SOUTH AFRICAN NOTICE TO MARINERS

February 2006 EDITION

**PUBLISHED MONTHLY
BY THE
HYDROGRAPHIC OFFICE
CAPE TOWN**

To accompany Notice to Mariners No 39 of 2006

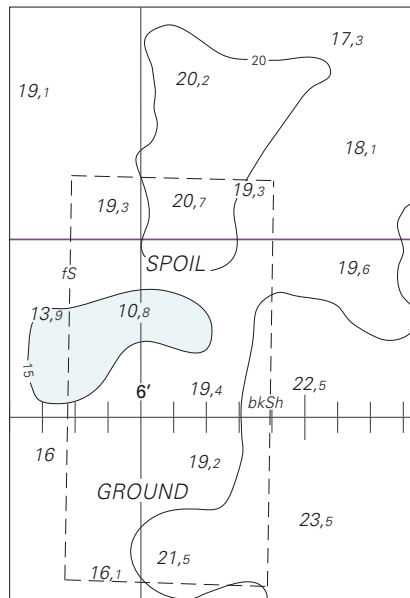
39* SOUTH AFRICA, South West Coast - Danger Point - Salmon dams

SAN 80 (INT 2680) [Previous Update 88/04] (2, 3a)

SAN 120 [Previous Update 38/01] (1, 2, 3b)

1. Insert : ----- joining following positions :

a.	34° 38'.0 S	019° 20'.1 E
b.	34° 40'.2 S	019° 20'.1 E
c.	34° 40'.2 S	019° 23'.3 E
d.	34° 40'.2 S	019° 24'.2 E
e.	34° 40'.0 S	019° 25'.4 E
f.	34° 37'.1 S	019° 24'.2 E
g.	34° 37'.5 S	019° 22'.0 E
h.	34° 38'.0 S	019° 20'.1 E

2. Insert :  centered on approximate position 34° 39'.2 S 019° 22'.4 E
(see Note)

3. Insert : The accompanying block correction in approximate position a) 34° 26'.5 S 019° 51'.0 E
b) 34° 21'.5 S 019° 37'.0 E

**SALMON MARINE FARM
(34°39' S 19°23' E)**

A Salmon Marine Farm is located within the Kleinbaai area. Floating net cages, an anchor spread and lit special marker buoys may be encountered within the area. All vessels, especially small craft are advised to navigate with extreme caution.
